# PD Modification Application: MM 24-1110

Development Services Department

## AGENCY REVIEW COMMENT SHEET

PETITION NO: MM 24-1110

## 8.2 Proposed Site Plan (Full)

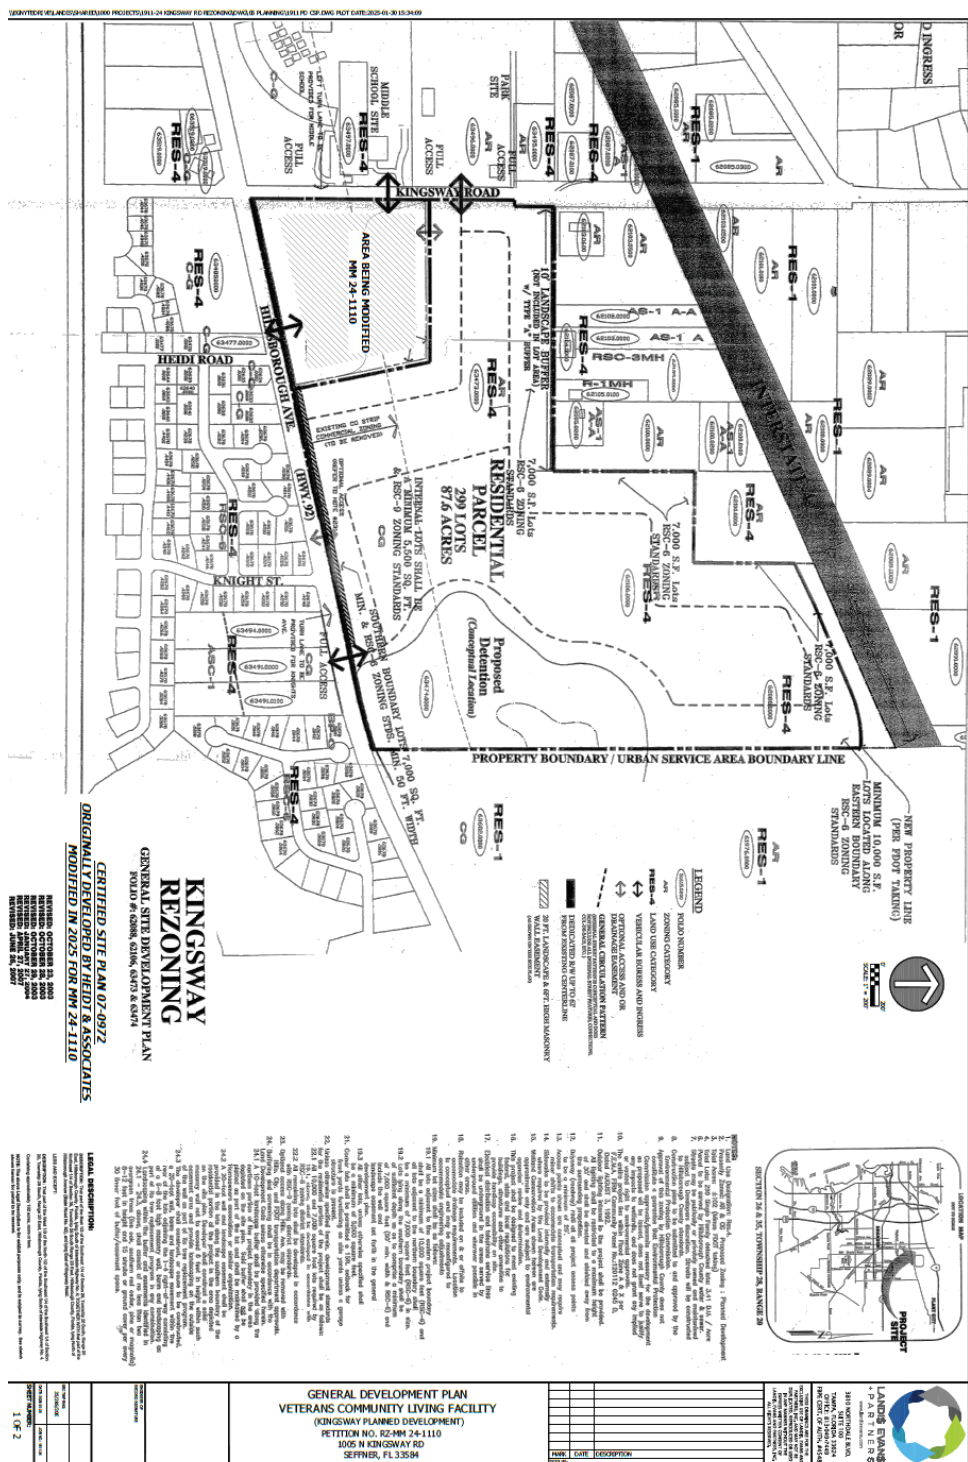
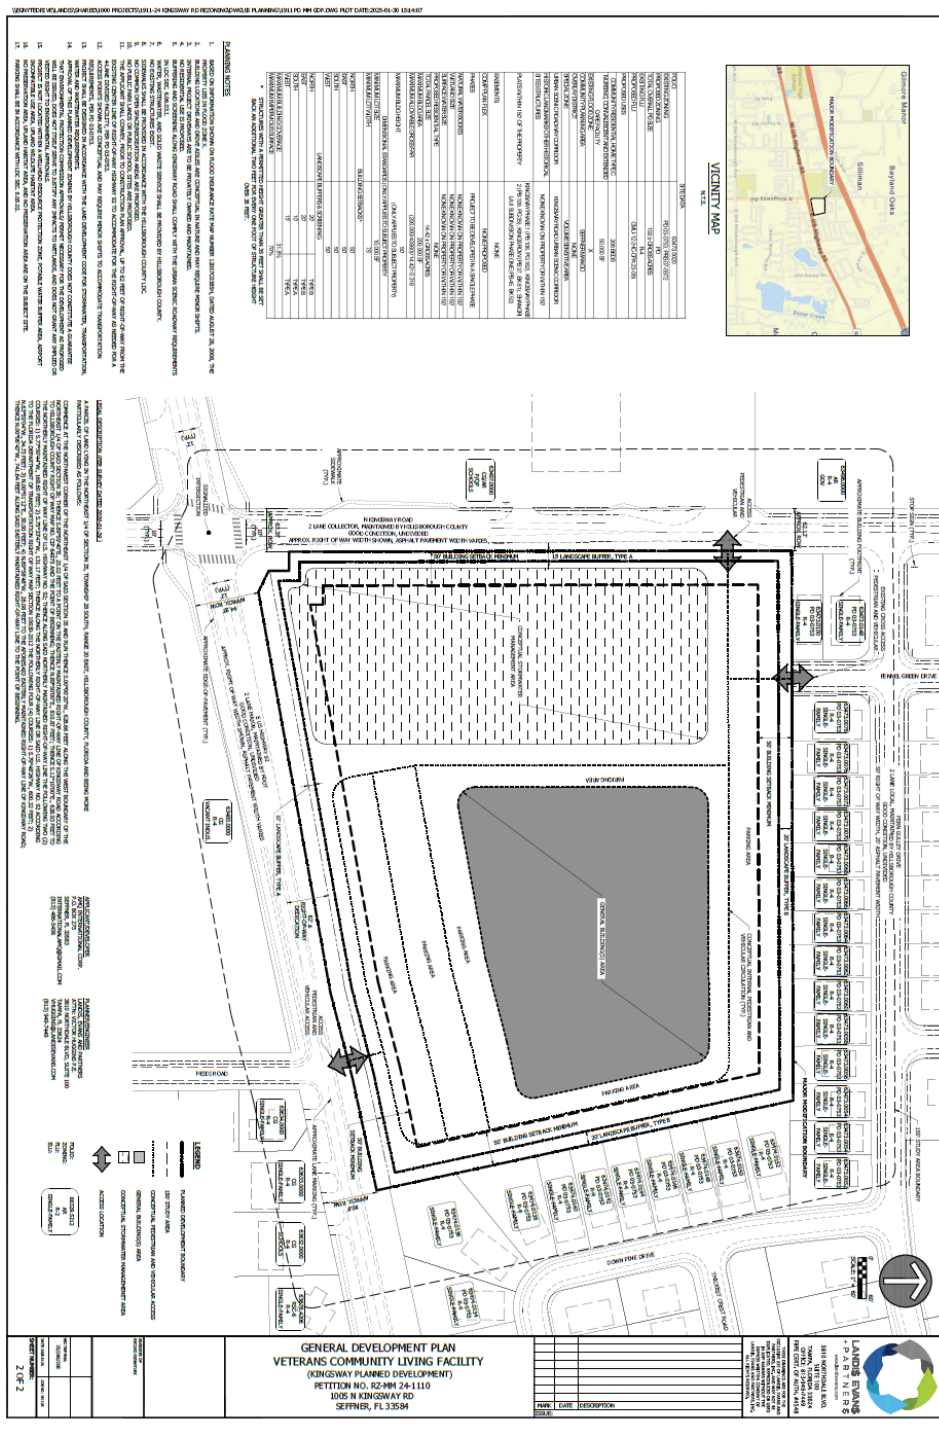
- Prior to PD certification, the developer shall revise the site plan as follows:
  - On sheet 1 of 2, remove the two access arrows from the "Area Being Modified" to Kingsway Rd. and US 92 (i.e. along the western and southern boundaries of the "Area Being Modified";

- On sheet 1 of 2, remove the two access arrows from the Area Being Modified to Kingsway Road and US 92;
  - On sheet 2 of 2, remove the three access from the "Area Being Modified" to along the western, northern and southern boundaries of the "Area Being Modified". Also remove any connecting linework (e.g. conceptual circulation patterns) to those arrows which could denote access. Staff notes that pursuant to the proposed conditions, access to these areas will be determined at the time of plat/site/construction plan review.

- On sheet 2 of 2, revise note 12 to instead state "Project access to the 24-1110 modification area will be determined at the time of plat/site/construction plan review."

- On sheet 2 of 2, correct the preservation label and linework. The preservation should be consistent with FDOT guidance on corridor preservation (see FDOT notes and above condition), and the measurement must start from the edge of the existing right-of-way line.
